Access Compliance Report Public Rights-of-Way (Curb Ramps)

Main Street: WESTON_PL		Cross Street: HOLT_AVE		Location:	NW
ADA ID: RPRK220124114751	Ramp Type: Type 4 - Parallel	Initial Pass/Fail: Fail	Overall Compliance: No	Severity Score:	15
Codes/Mitigation Info/Possible Solution			Field Measurements/Component Compliance

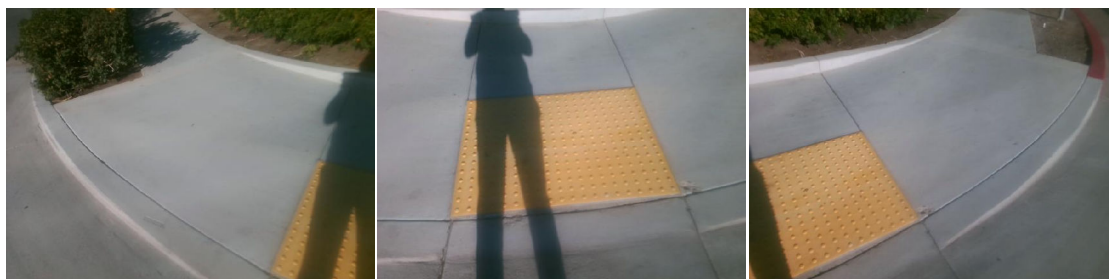
Compliance	Description	Data	Compliance	Description	Data
N/A	Ramp Length LT (in)	90	N/A	Ramp Length RT (in)	94
Yes	Ramp Width LT (in)	86	Yes	Ramp Width RT (in)	86
Yes	Ramp Run Slope LT (%)	4.6	Yes	Ramp Run Slope RT (%)	7.6
Yes	Ramp Cross Slope LT (%)	1.3	No	Ramp Cross Slope RT (%)	6.2
N/A	Landing Present	N/A	N/A	DWS Provided	N/A
N/A	Landing Length (in)	N/A	N/A	DWS Contrast	N/A
N/A	Landing Width (in)	N/A	N/A	DWS Length (in)	N/A
N/A	Landing Run Slope (%)	N/A	N/A	DWS Full Width	N/A
N/A	Landing Cross Slope (%)	N/A		DWS Offset Type	N/A
N/A	Landing Movement Obstructed?	N/A	N/A	DWS Offset Left (in)	N/A
	Landing Movement Type	N/A	N/A	DWS Offset Right (in)	N/A
N/A	Landing Shared	N/A			
N/A	Clear Space	Yes			
N/A	Clear Space To Crosswalk (in)	N/A			
N/A	Marked Crosswalk 1	No	N/A	Marked Crosswalk 2	No
	Crossing 1 Direction	S		Crossing 2 Direction	E
	Marked Crosswalk 1 Width (in)	N/A		Marked Crosswalk 2 Width (in)	N/A

Remove & Replace Curb Ramp With Two New Directional Ramps or Equivalent.

R304.5.3, STD 1115
